INDESIT company

MBA4531NF

F029854

RE0229T0 Exploded views

0999342: Aluminium separator dimentions

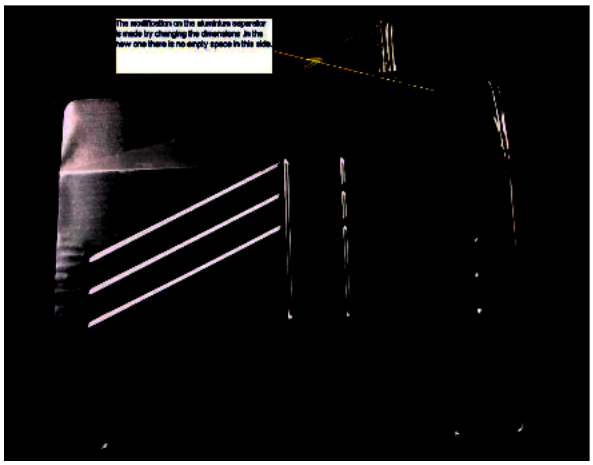
Modification on the aluminium separator is made by changing the dimentions. On the new one there is no empty space at the corner.Spare part code remain the same.

0999344: length of rezistance

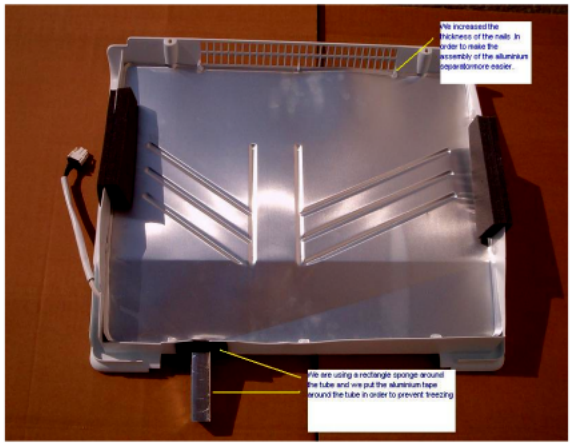
Length of rezistance which is placed on aluminium seperator has been increased.
